## SUMMARY OF CONCERNS IN RELATION TO THE PROPOSED NORTHCONNEX TUNNEL

This is an objection to many aspects of the proposed NorthConnex tunnel.

## SECTION A: THE CONNECTIVITY OF NORTHCONNEX SOUTHERN VENTILATION FACILITY AT THE SOUTHERN INTERCHANGE, THE SOUTHBOUND TUNNEL IN PARTICULAR

Figure 5-17 Motorway operations complex

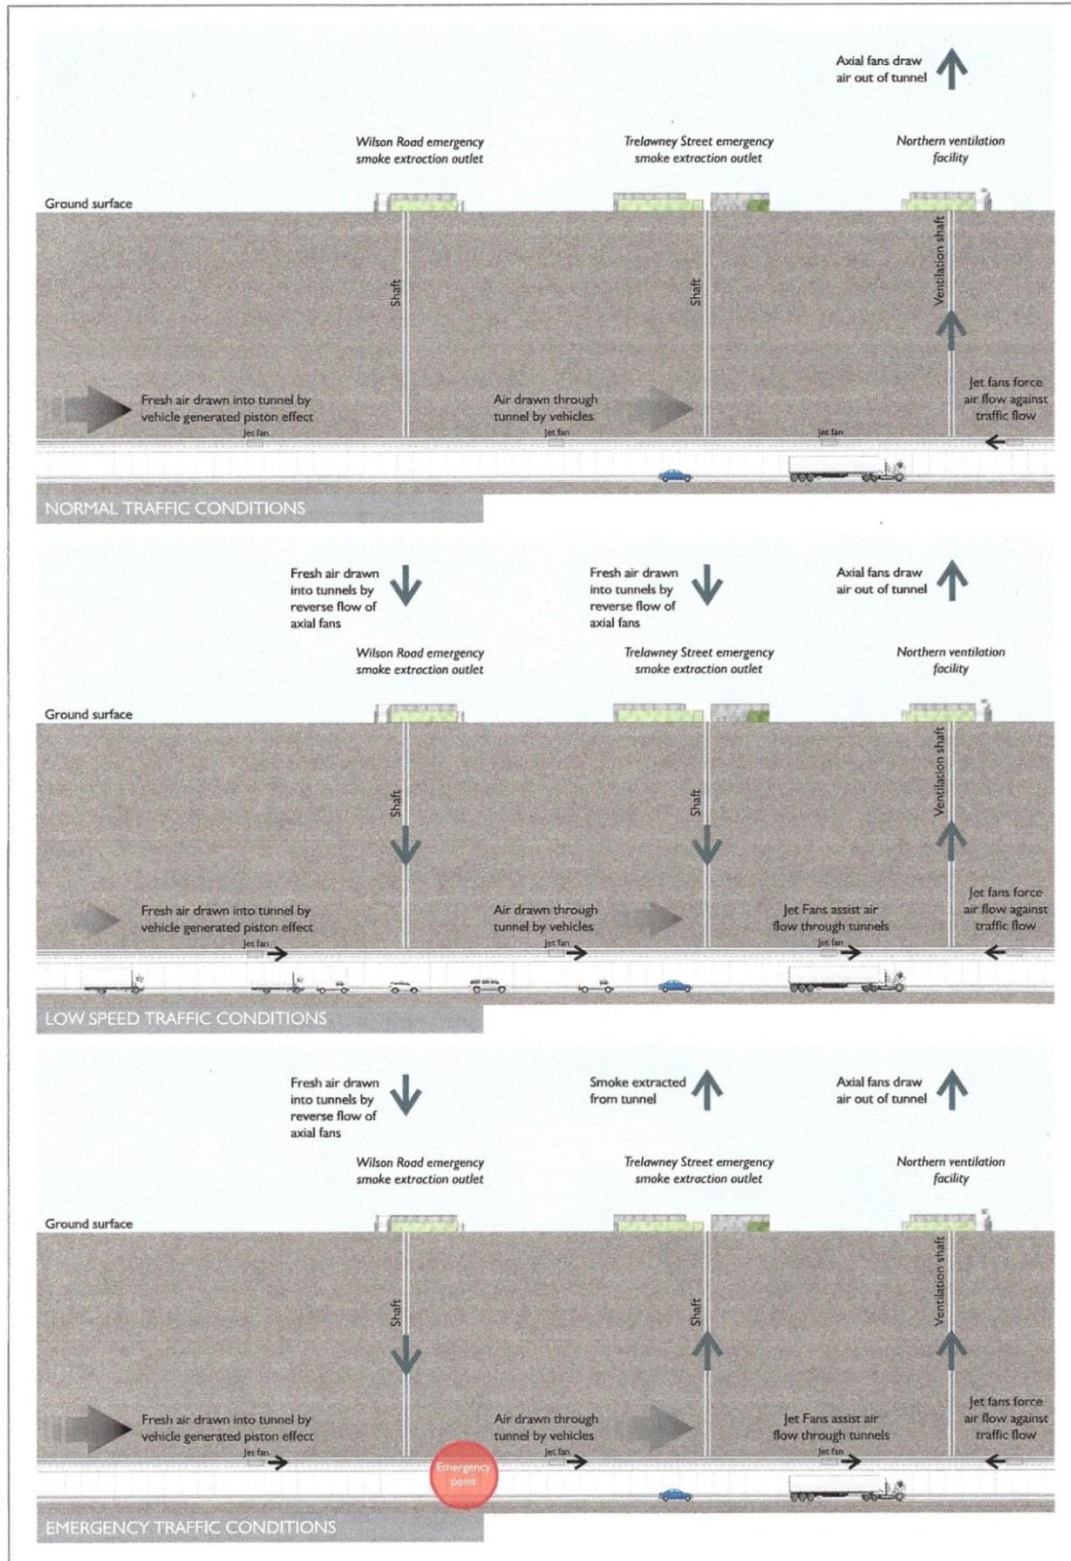
EIS Page 111, *Figure 5-17 Motorway operations complex*

*Page 8 below* there is no indication of how the ventilation facility will be connected to either the northbound or southbound tunnel, nor is there any indication of how the southbound exit portal onto Pennant Hills Road or the south-west exit portal onto the M2 will be connected.

In each of the above figures for Wilson Road, Trelawney Street, and Northern Ventilation facility, the shafts, emergency smoke extraction buildings, and ventilation facility make a substantial footprint in the construction area; however for the Southern Interchange the ventilation facility is an insignificant part of the construction area. How can this be? The difference in scale does not explain the difference.

We also find it disturbing that in each of the above figures for Wilson Road, Trelawney Street, and Northern Ventilation facility the headings are for “*tunnel support facility operational layout*” and “*ventilation facility operational layout*” but for the Southern Interchange the description is for “*Motorway operations complex*” with no mention of the ventilation facility or the tunnels.

- Will the Southern Ventilation facility be connected to the southbound tunnel? In the complete absence of any indication in the EIS that this will occur, it is necessary that this question receive a direct confirmation or denial in writing.
- Where will the connection be?
- How will the polluted air from the tunnel reach the ventilation facility which is across a busy 6-lane highway?
- A diagram such as that in the EIS Page 103, *Figure 5-14 Indicative tunnel ventilation system northbound tunnel arrangement* must be provided showing how this will work for the southern interchange. Clearly the polluted air cannot be drawn upward if the ventilation facility is across the road.

- Diagrams need to be provided showing the inter-relation between the shaft, the ventilation outlet and the motorway operations centre with a clear description of what is to be constructed and how it will operate.
- The community needs irrefutable evidence that the polluted air from the southbound tunnel exit portals will not be allowed to flow like an invisible sewer through West Pennant Hills, North Rocks, Carlingford and Beecroft.

Figure 5-38 Indicative southern interchange construction compound

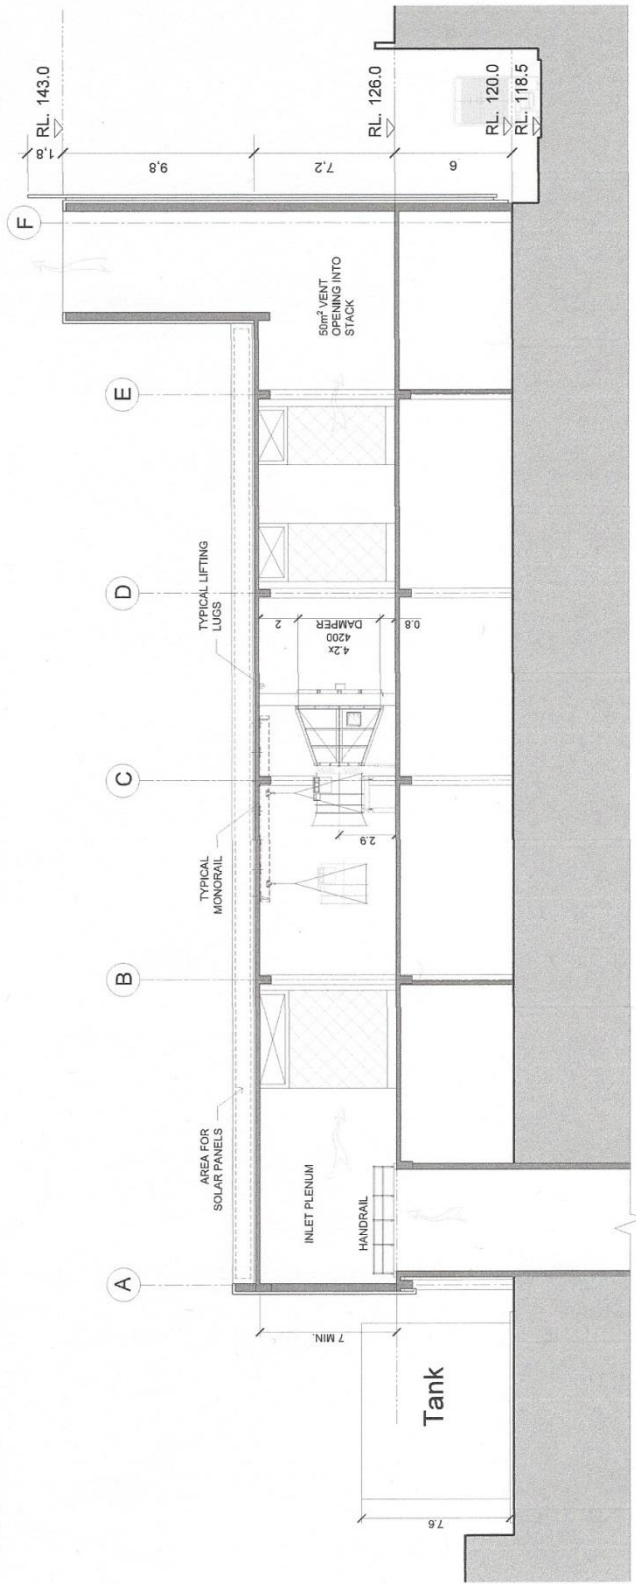
3. EIS Page 189 *Figure 5-38 Indicative southern interchange construction compound* *Page 9 below*  
This is the first in a range of illustrations (*Figures 5-38 to 5-44*) all dealing with the construction compounds.

It is ominous that the southern ventilation facility and shaft are completely absent from Figure 5-38.

MOTORWAY OPERATIONS COMPLEX - SOUTHERN VENTILATION FACILITY - SECTIONS  
M1-M2-5000-DR-JD-0525

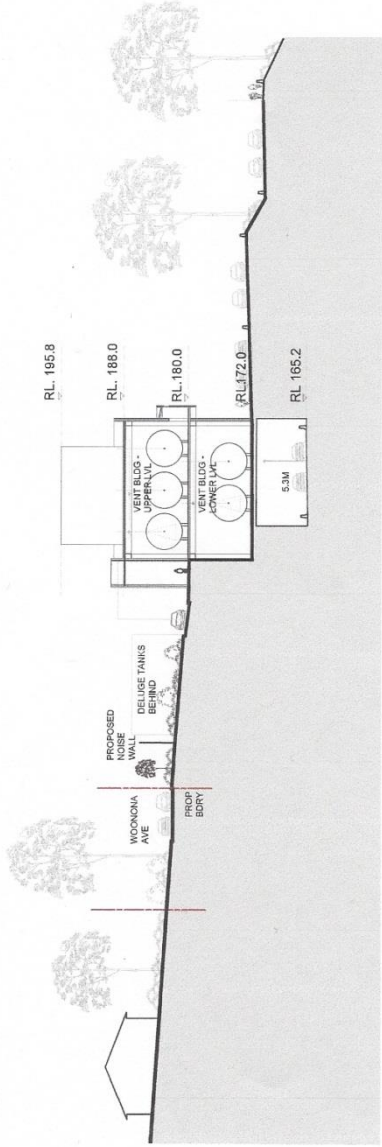
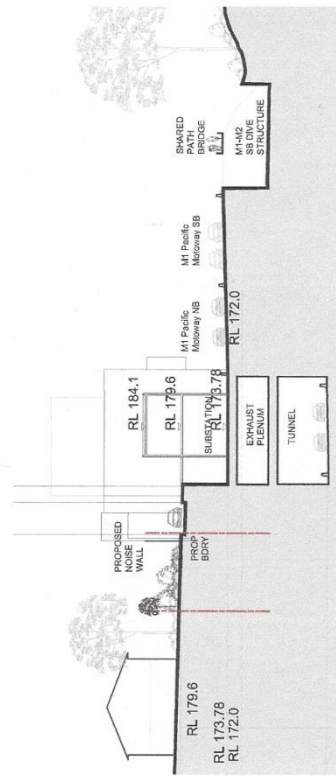
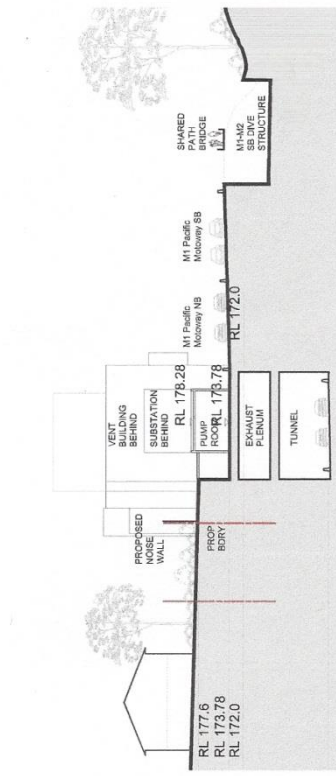
5. *EIS Volume 4, Technical working papers - Urban Design, 6.0 Operational Ancillary Facilities*  
EIS Page 99 there is the diagram "Motorway Operations Complex – Southern Ventilation Facility – sections. Page 10 below The diagram has the cryptic label "Connection to tunnel TBC". What does TBC stand for? To be considered? Why is tunnel singular? Which tunnel is the diagram referring to northbound or southbound? There is no diagram showing any connection from the Southern Interchange ventilation facility to either the northbound or the southbound tunnel in any way AND YET ....
